5-A-24-HZ
APPLICATION FOR CERTIFICATE OF APPROPRIATENESS

523 E. Oklahoma Ave. 37917
Old North Knoxville H

Staff Report

File Number: 5-A-24-HZ

523 E Oklahoma Ave: Entry Door Support

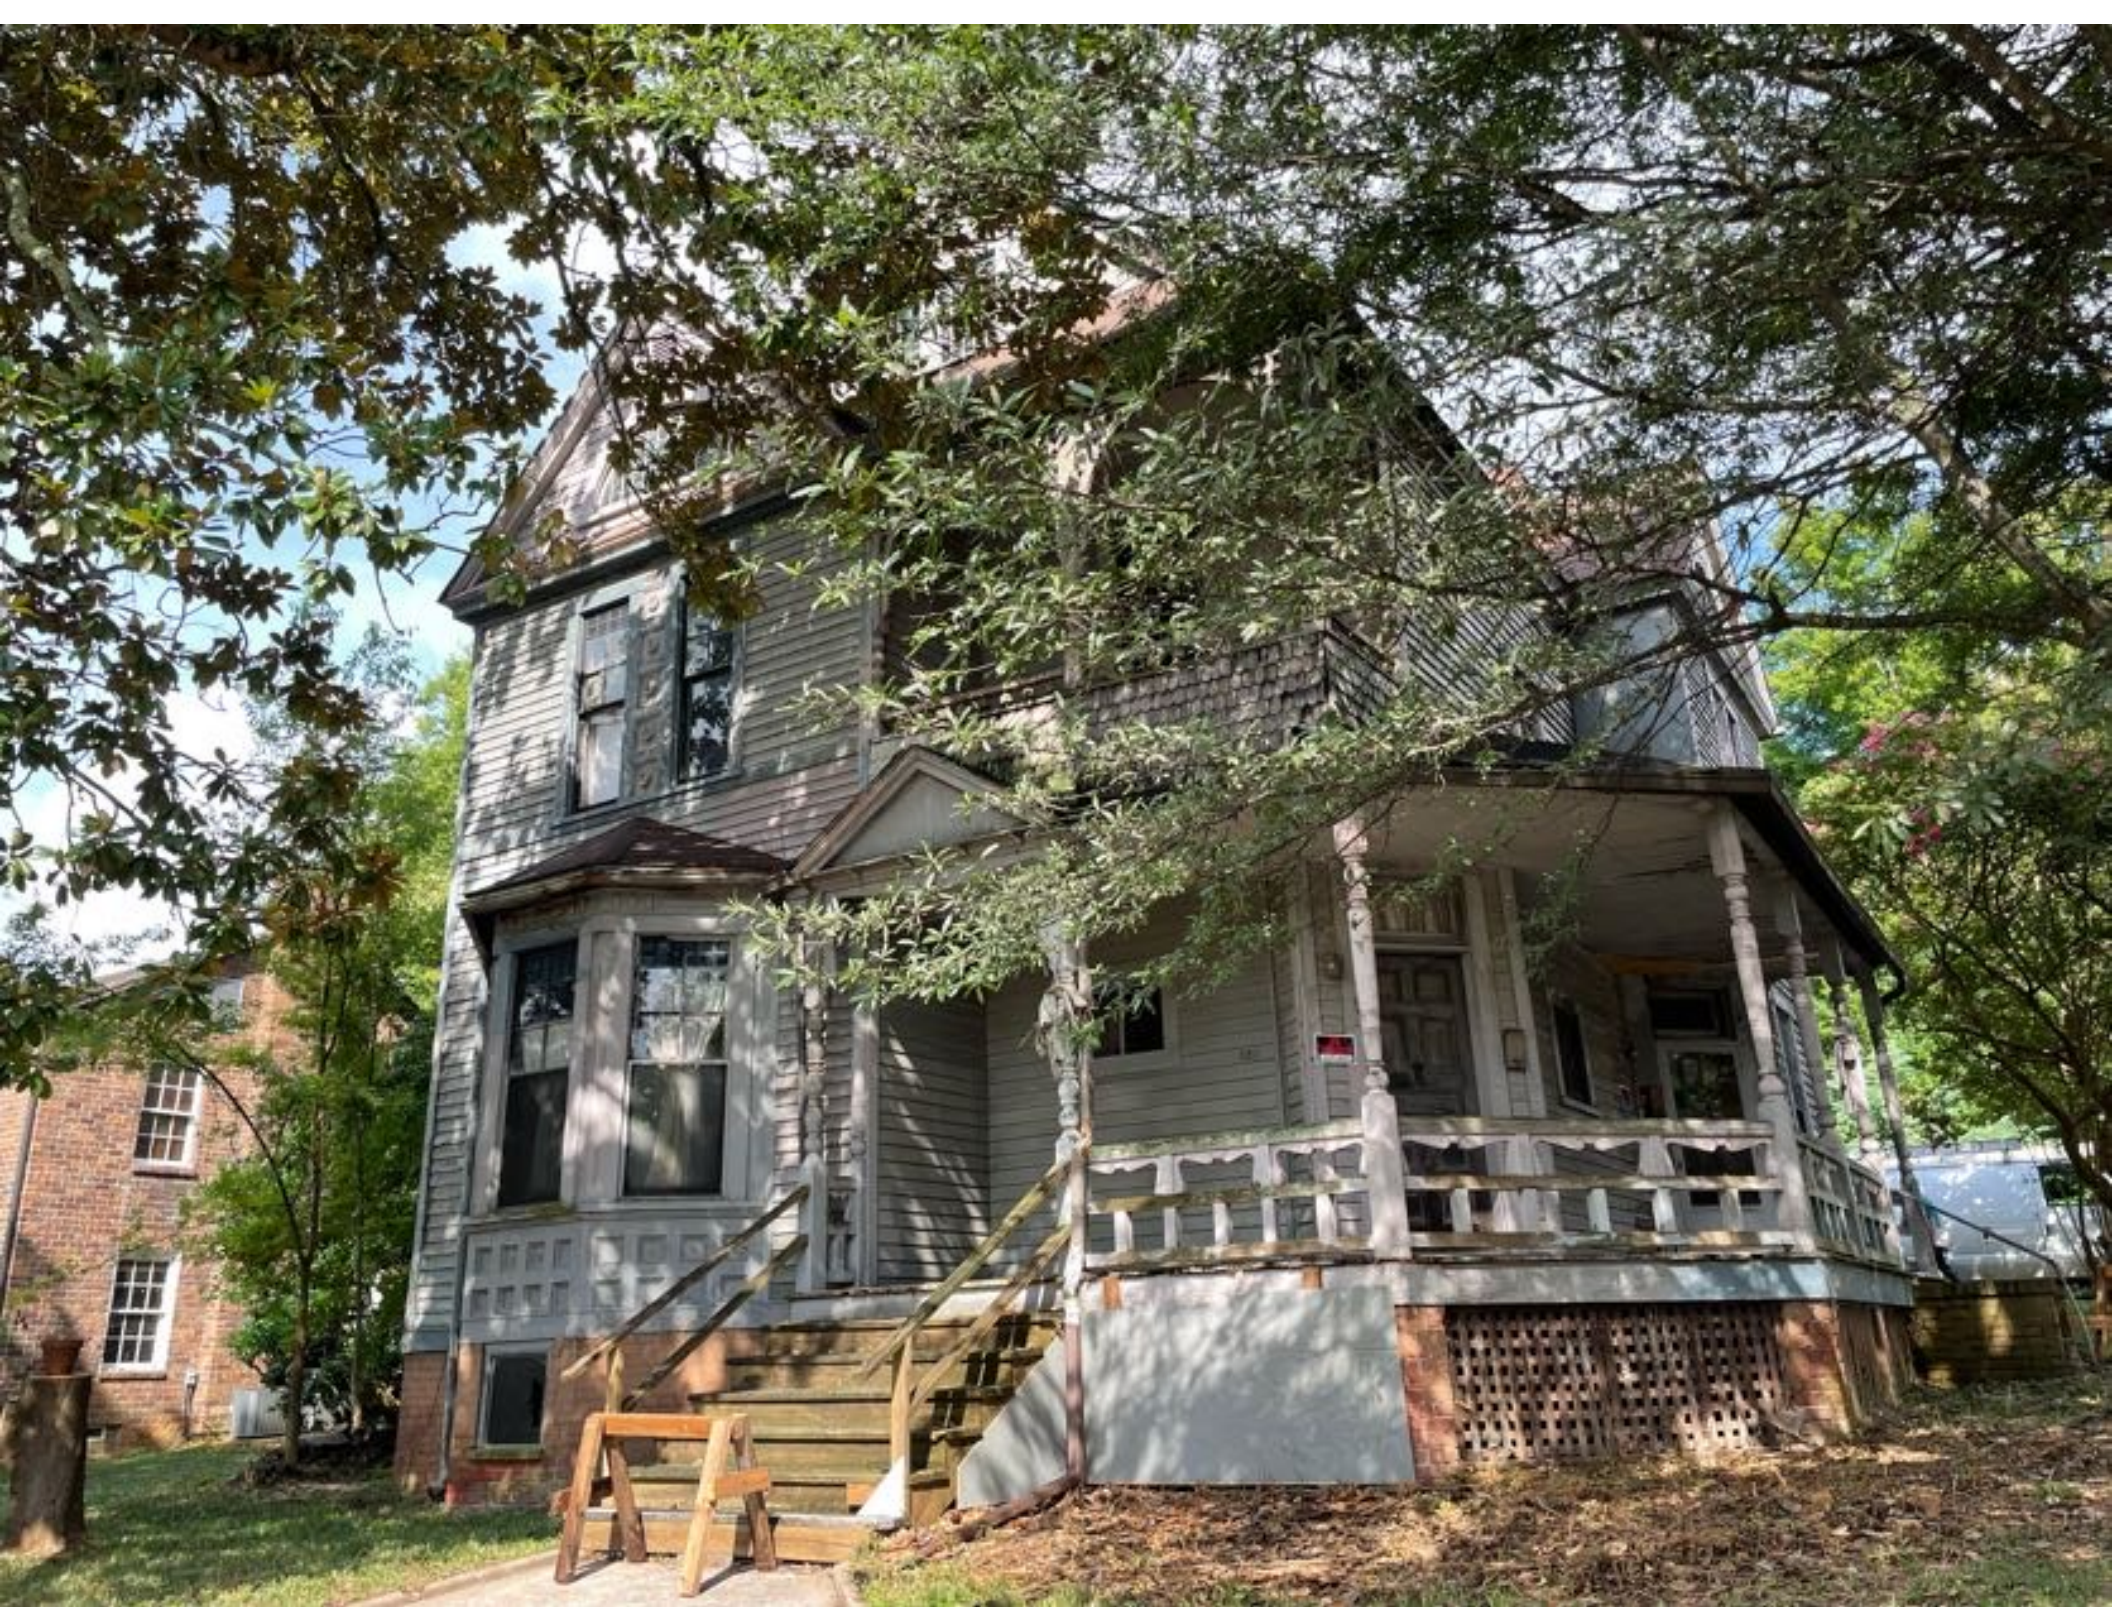
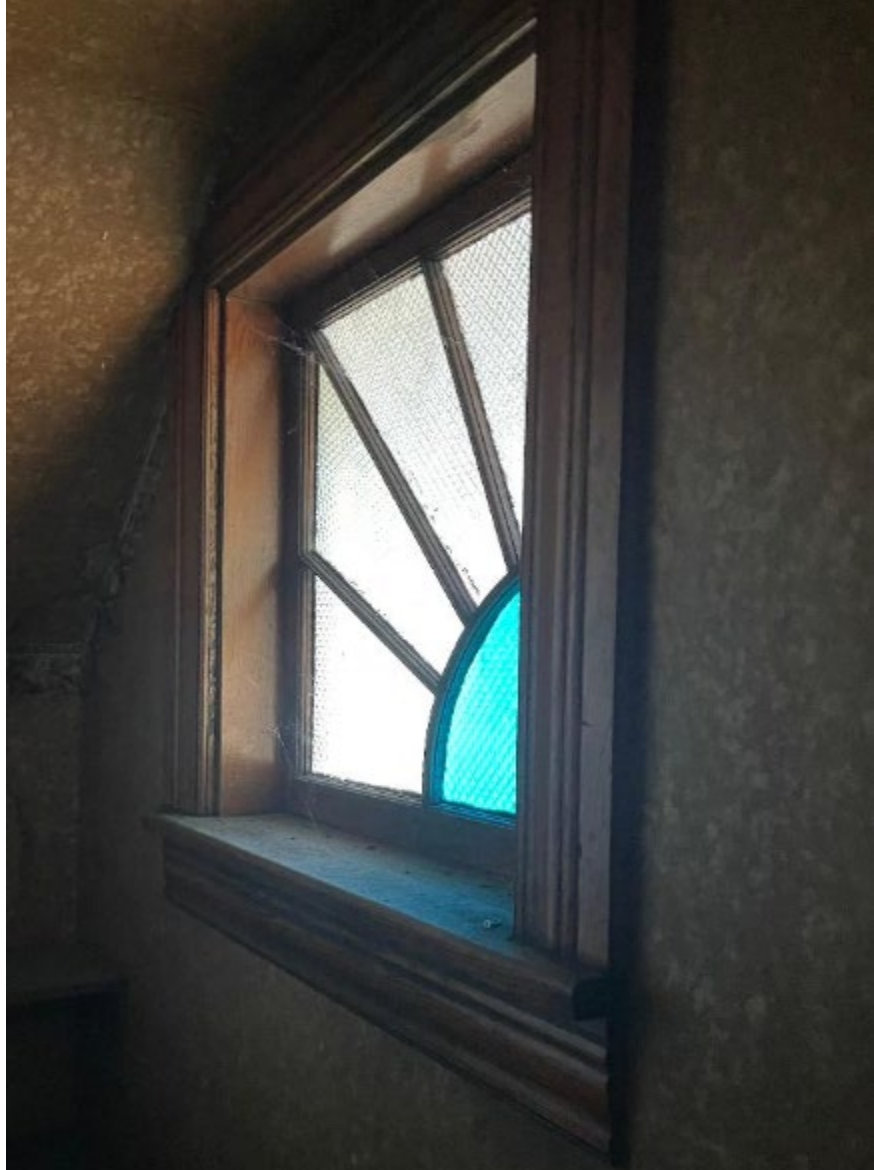
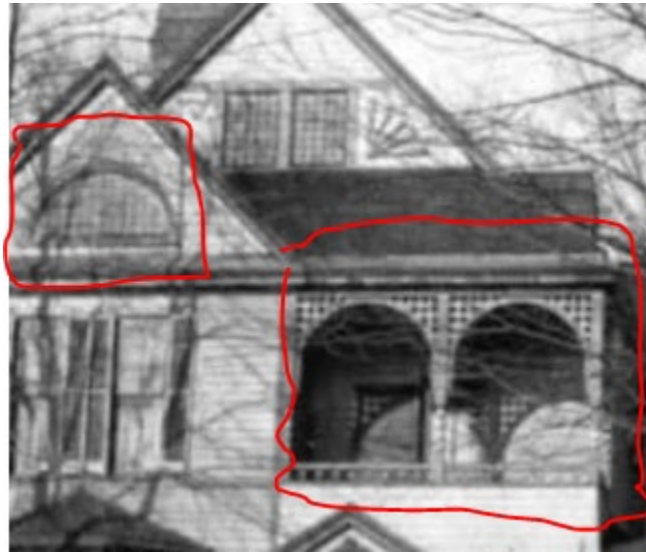
3. The door proposed for replacement is not in its original location; the original door was removed when the interior of the house was converted to multiple units. A c.1930 photograph provided by the applicant shows the current multi-panel wood door in its original central location. Restoring the original front entry fenestration is appropriate within the design guidelines.

4. The application notes that no documentation of the original door exists. The Commission should discuss whether the c.1930 door acquired significance in its own right, and how the proposed door could avoid creating a “false historic appearance” per the guidelines. The proposed arched wood double door is compatible in size and material with the façade. The door contains details that align with existing details on the house, including the fanlight window and other arched openings on gable windows and the porch.

Staff recommends approval of Certificate 5-A-24-HZ, subject to one condition: 1) applicant to submit final window specification to staff for approval.

Option 1: This is the preferred option that is identical to the other primary windows, if somewhat wider.

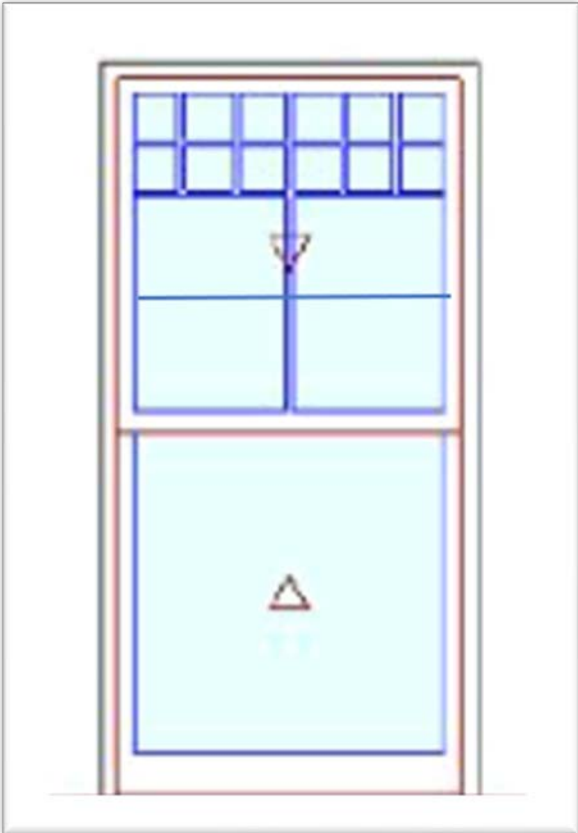
5. Installation of a new window in the projecting façade bay is appropriate within the guidelines; the proposed windows are compatible in materials, scale, and design with the existing windows. The double-hung options should be selected instead of a fixed window, to be compatible with the operation of most of the house’s original ground-floor windows. The applicant should provide a specification for the final selection to staff for approval.
-
